MILITARY SPECIFICATION

TRANSISTOR, PNP, GERMANIUM, POWER

TYPES 2N1412 AND 2N1412A

This amendment forms a part of Military Specification MIL-S-19500/76C(NAVY), dated 20 September 1967.

FIGURE 1. Physical dimensions of transistor, types 2N1412 and 2N1412A.

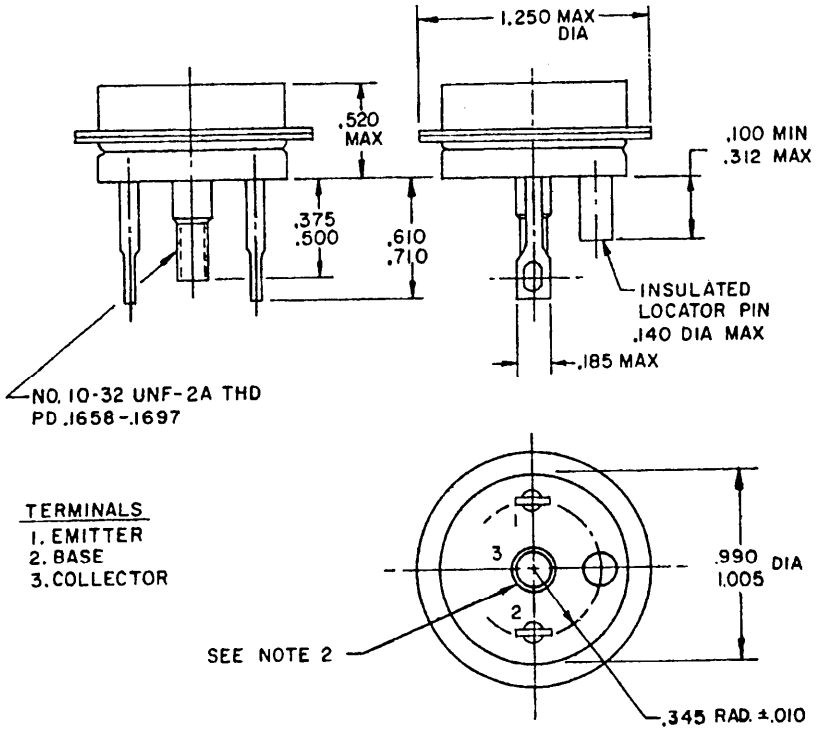
Delete figure 1 and substitute the attached figure 1.

FIGURE 3. V_{CEX}(sus) test.

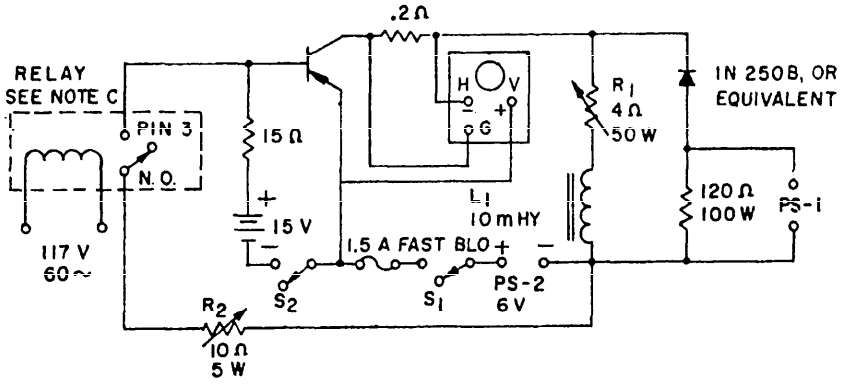
Delete figure 3 and substitute the attached figure 3.
